802.1ah: CBP Address Translation

Stephen Haddock
September 5, 2007
802.1 Interim, Stockholm

d3.6 CBP address translation rules

d3.6 Problem with CFM individual address

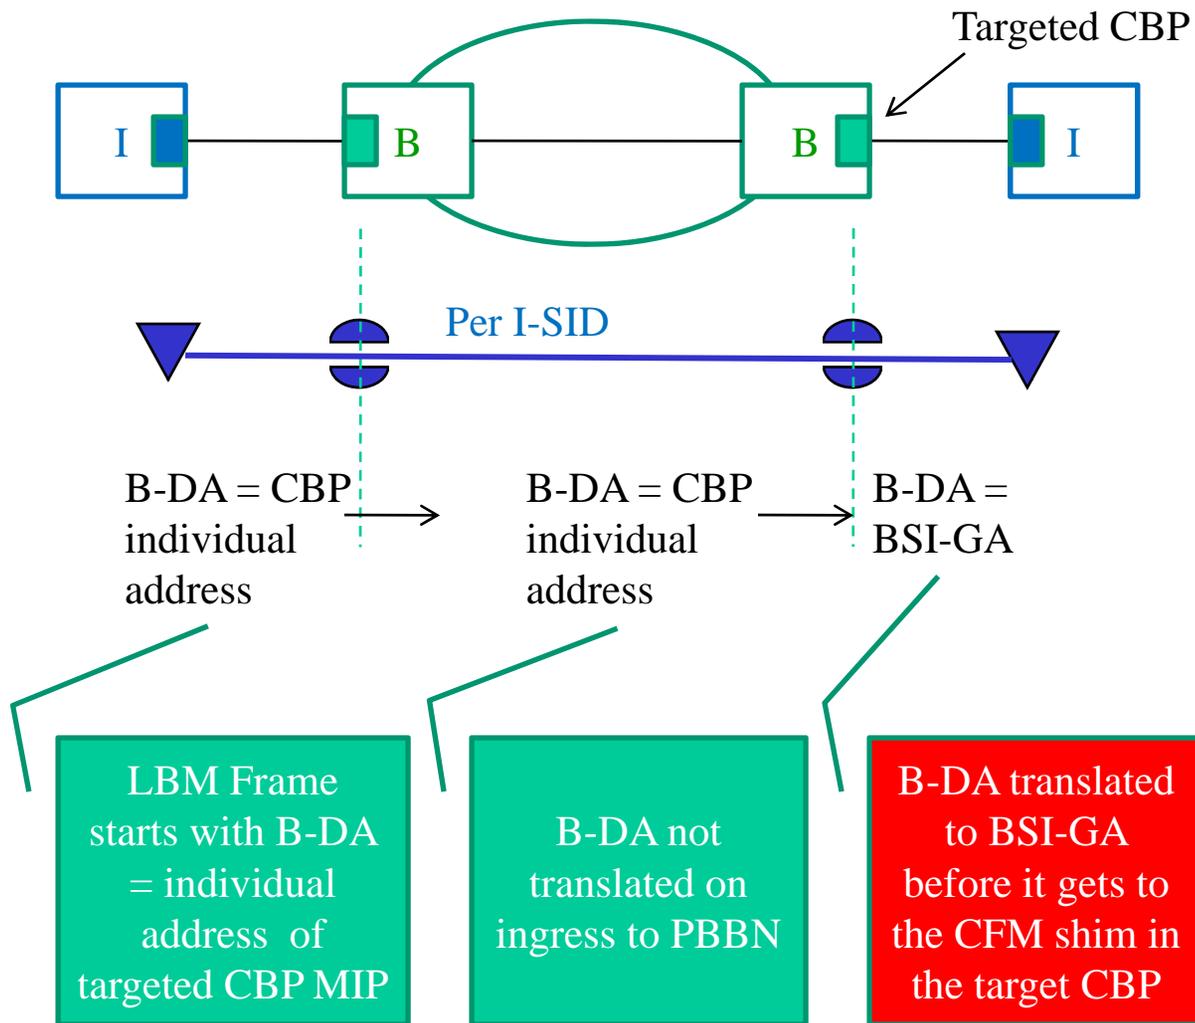
- 1) Make egress translation dependent on NCA bit (don't translate B-DA of backbone service instance level CFM).
- 2) CBP has two individual addresses: one for CFM shims and one for B-DA on user data frames.
- 3) Don't allow translating B-DA of user data frames to/from CBP individual address.
- 4) Put CFM shims above CBP functions (6.11) in interface stack.

Resolution d3.6 → d3.7

- In San Francisco we selected option 1, but it had a fundamental problem:
 - It solved the original problem statement, but ...
 - CFM frames that are created with a CCM or LTM group address can have that translated to a CBP individual address. At that point they are indistinguishable from CFM frames created with the CBP individual address.
 - Not translating the CBP individual address back to the backbone service instance group address (BSIGA) based on the NCA bit is the wrong decision if the original address was the BSIGA.
 - Translating the CBP individual address to the BSIGA is the wrong decision if the original address was the CBP individual address.
- Therefore d3.7 went to the second proposed solution: the CBP translation function uses a different individual address than the CBP CFM shims.
